MUNICIPALITY OF ANCHORAGE PLANNING DIVISION

MEMORANDUM

CASE NO.: 2014-0195

REQUEST: A conditional use to allow a natural resource extraction per AMC 21.05.060B.6. and 21.50.070.

Natural Resource Protection Plan
 Checkpoint Subdivision
 Tract A

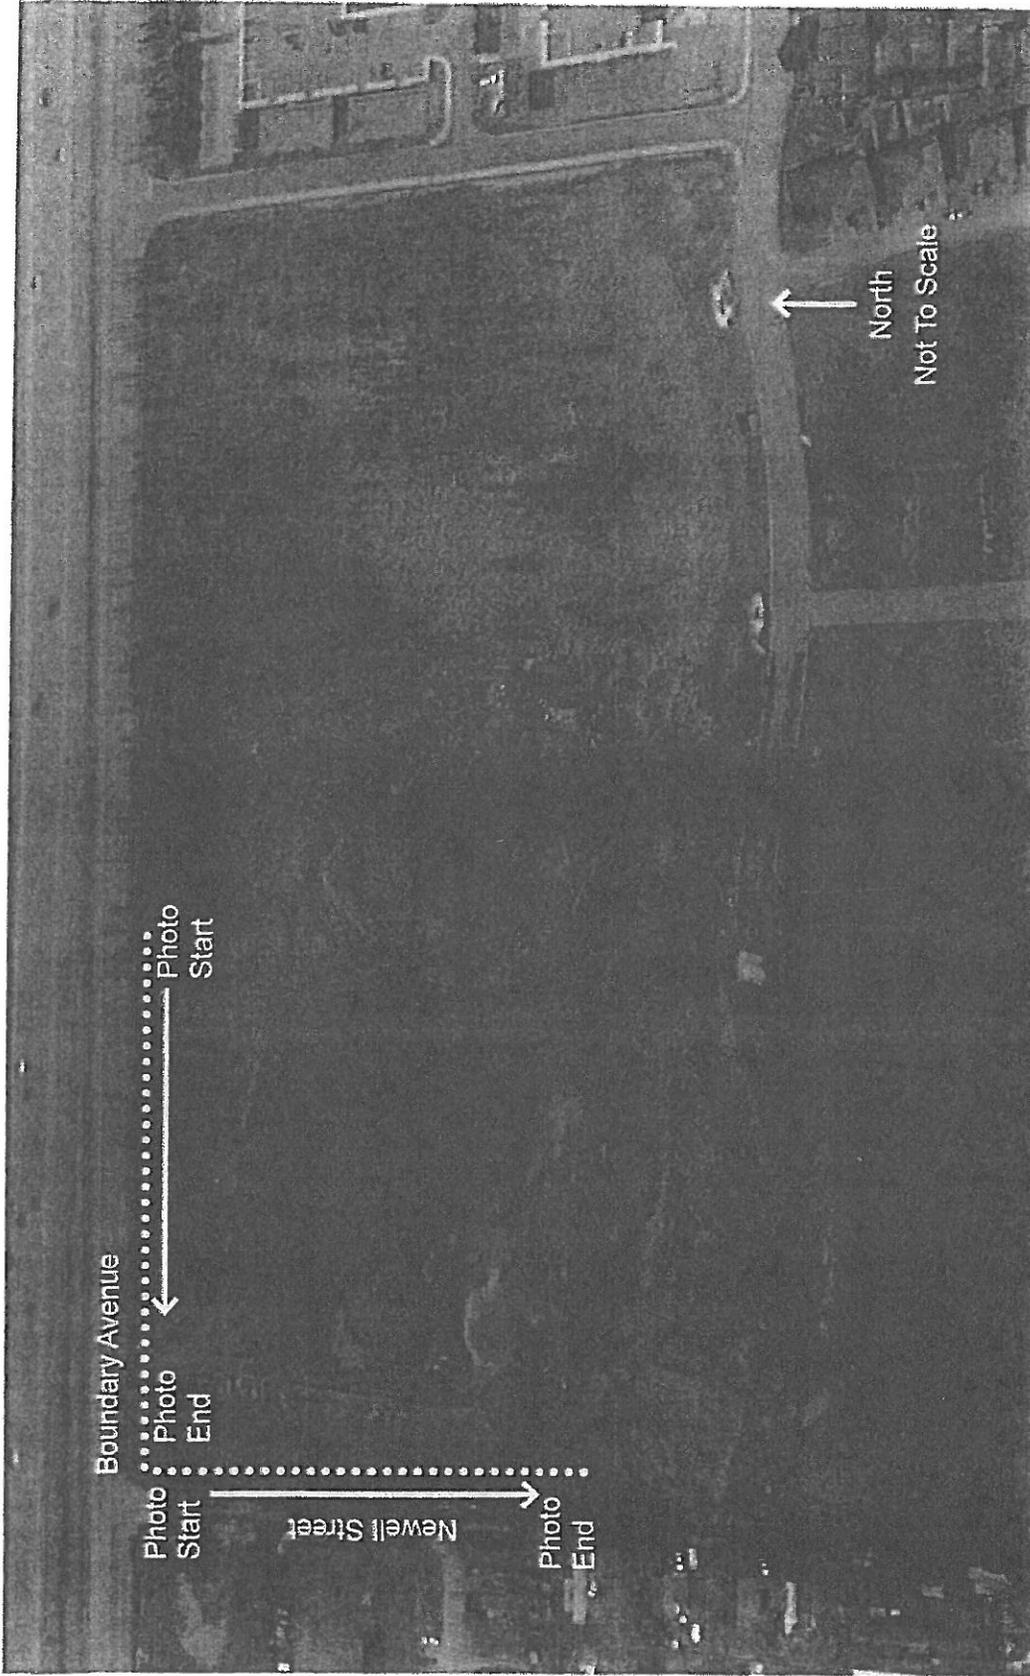
The Extraction Plan shows what appears to be an 8' high berm adjacent to the commercial business and 4' -8' feet high berm adjacent to the mobile home park. The berm height transition from 8' to 4' is not clearly indicated on the plan.

The physical characteristics of the site are adequate for the peat extraction. The Extraction Plan shows what appear to be berms 4'-8' high that will help mitigate noise and visual impacts on the adjacent business and residences to the east, west, and south.

The Extraction Plan indicates that a native vegetation buffer does not exist or will not remain to buffer the residences to the west of the subject property. The northern half of the site shows buffer native vegetation, the southern half does not. The petitioner will need to provide L3 screening landscaping for areas adjacent to residential zones prior to extraction activities.

14. Provide a haul route plan to the Traffic Division.
 15. Install L3 screening landscaping for areas adjacent to residential zones prior to extraction activities. Provide a landscape plan to the Planning Division for approval prior to installation.

7. SITE CROSS SECTION

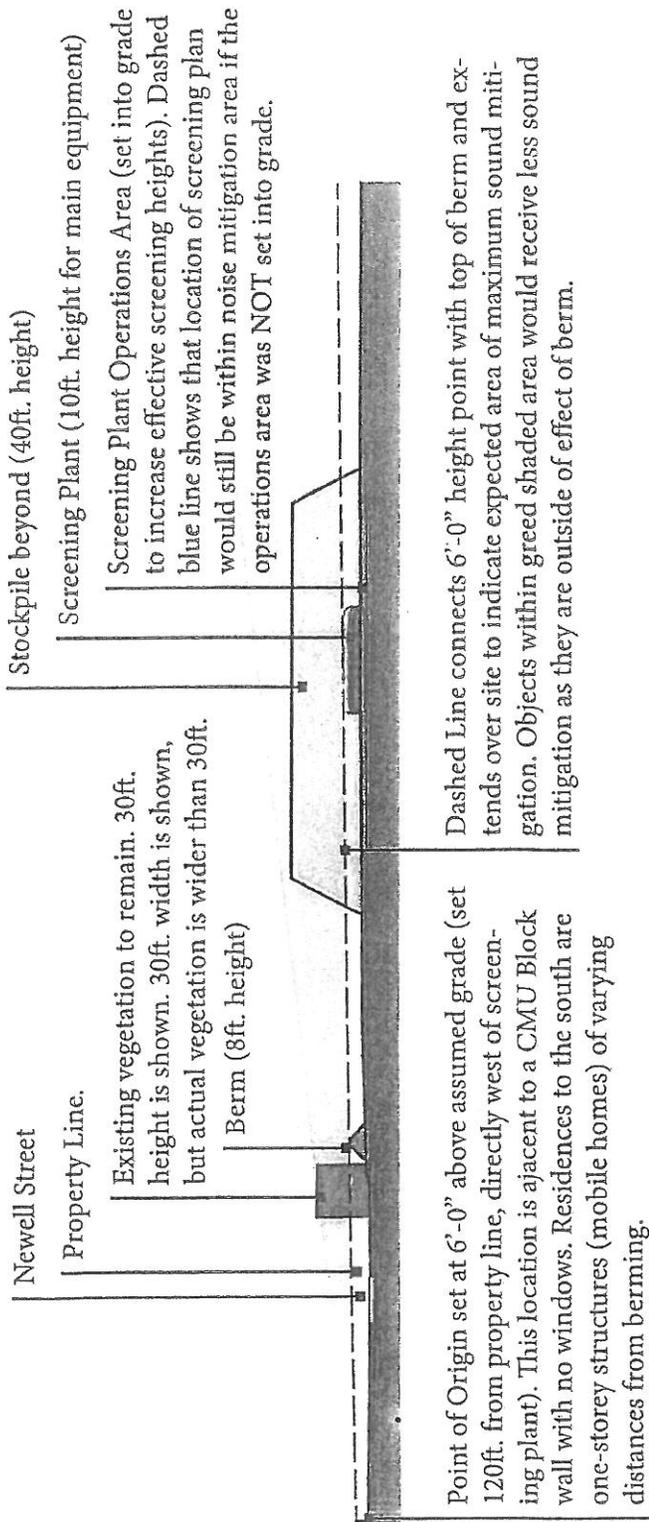
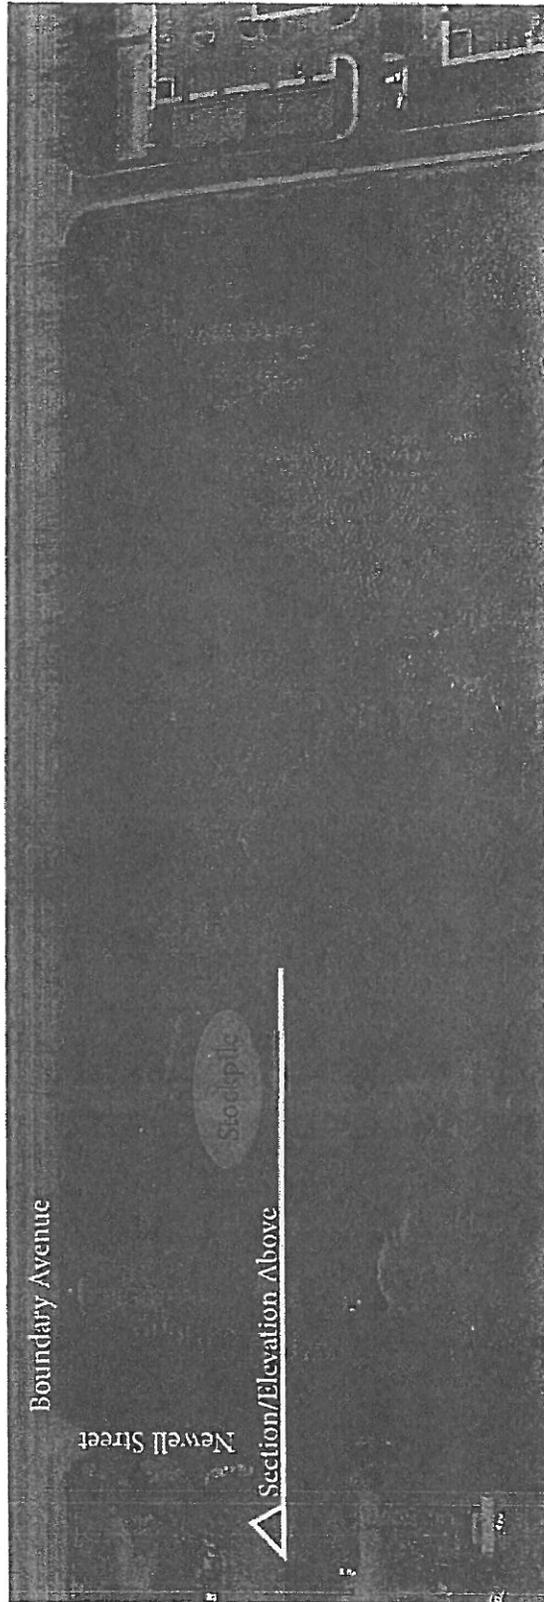
The proposed earth berms may do little to mitigate noise from the screening plant or equipment operating near it, due to their height (8 feet) and placement (more than 150 feet from the nearest residences and 200 feet from the screening plant). Any equipment operating on the stockpiles will be located higher than the berm, thus making the berm relatively ineffective at limiting noise from those operations. Berms are most effective when placed close to the source of noise or close to the receiver and at least high enough to block the line of sight between the receiver and the source.

The proposed earth berms may do little to mitigate noise from the screening plant or equipment operating near it, due to their height (8 feet) and placement (more than 150 feet from the nearest residences and 200 feet from the screening plant). Any equipment operating on the stockpiles will be located higher than the berm, thus making the berm relatively ineffective at limiting noise from those operations. Berms are most effective when placed close to the source of noise or close to the receiver and at least high enough to block the line of sight between the receiver and the source.

5. Provide a noise study and mitigation plan approved by DHHS.
6. Provide a dust control plan approved by DHHS.
7. Provide the following required information to the Current Planning Section:
